Steering Head Screw  
Models: M.Y. 2010 Multistrada 1200 (all versions)  
Recall Bulletin RCL-10-003

Date: Monday, July 26, 2010  
To: Dealer Principal, Service Manager, North American Dealer Network  
From: Austin Gray, Technical Director; Jonathan LaForte, Technical Manager

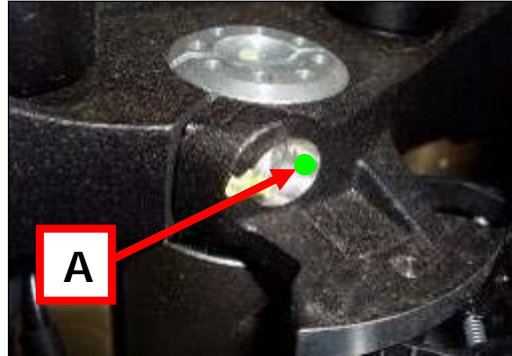
- On a production lot, an M8x25 8.8 screw has been incorrectly installed onto the steering head instead of the required M8x28 10.9 screw.

- The frames listed in the above table need to be modified immediately by recalling the motorcycles delivered to final customers or during the pre-delivery operations.
- Replace the steering head screw with the above-mentioned M8X28 10.9 screw, **Part. No. 771.5.726.8C**, and tighten to **18 Nm ± 5%** with graphitized grease.
- After such intervention, use an indelible green felt pen and draw a dot in a visible position on the steering head (A) to indicate that the modification was carried out.

- Replace the steering head screw with the above-mentioned M8X28 10.9 screw, **Part. No. 771.5.726.8C**, and tighten to **18 Nm ± 5%** with graphitized grease.
